On this one Columbia slide, a PowerPoint festival of bureaucratic hyper-rationalism, 6 different levels of hierarchy are used to display, classify, and arrange 11 phrases:

The analysis begins with the dreaded Executive Summary, with a conclusion presented as a headline: “Test Data Indicates Conservatism for Tile Penetration.” This turns out to be unmerited reassurance. Executives, at least those who don’t want to get fooled, had better read far beyond the title.

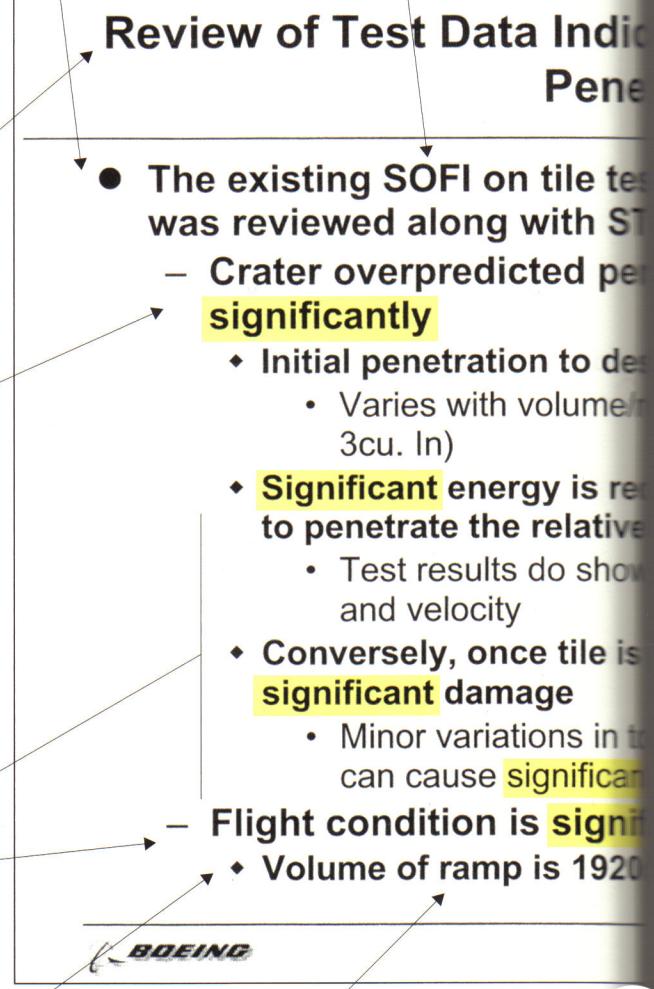
The “conservatism” concerns the *choice of models* used to predict damage. But why, after 112 flights, are foam-debris models being calibrated during a crisis? How can “conservatism” be inferred from a loose comparison of a spreadsheet model and some thin data? Divergent evidence means divergent evidence, not inferential security. Claims of analytic “conservatism” should be viewed with skepticism by presentation consumers. Such claims are often a rhetorical tactic that substitutes verbal fudge factors for quantitative assessments.

As the bullet points march on, the seemingly reassuring headline fades away. Lower-level bullets at the end of the slide undermine the executive summary. This third-level point notes that “Flight condition [that is, the debris hit on the Columbia] is significantly outside of test database.” How far outside? The final bullet will tell us.

This fourth-level bullet concluding the slide reports that the debris hitting the Columbia is estimated to be $1920/3 = 640$ times larger than data used in the tests of the model! The correct headline should be “Review of Test Data Indicates Irrelevance of Two Models.” This is a powerful conclusion, indicating that pre-launch safety standards no longer hold. The original optimistic headline has been eviscerated by the lower-level bullets. Note how close attentive readings can help consumers of presentations evaluate the presenter’s reasoning and credibility.

The Very-Big-Bullet phrase fragment does not seem to make sense. No other VBB’s appear in the rest of the slide, so this VBB is not necessary.

Spray On Foam Insulation, a fragment of which caused the hole in the wing

Here “ramp” refers to foam debris (from the bipod ramp) that hit Columbia. Instead of the cryptic “Volume of ramp,” say “estimated volume of foam debris that hit the wing.” Such clarifying phrases, which may help upper level executives understand what is going on, are too long to fit on low-resolution bullet outline formats. PP demands a shorthand of acronyms, phrase fragments, clipped jargon, and vague pronoun references in order to get at least some information into the tight format.
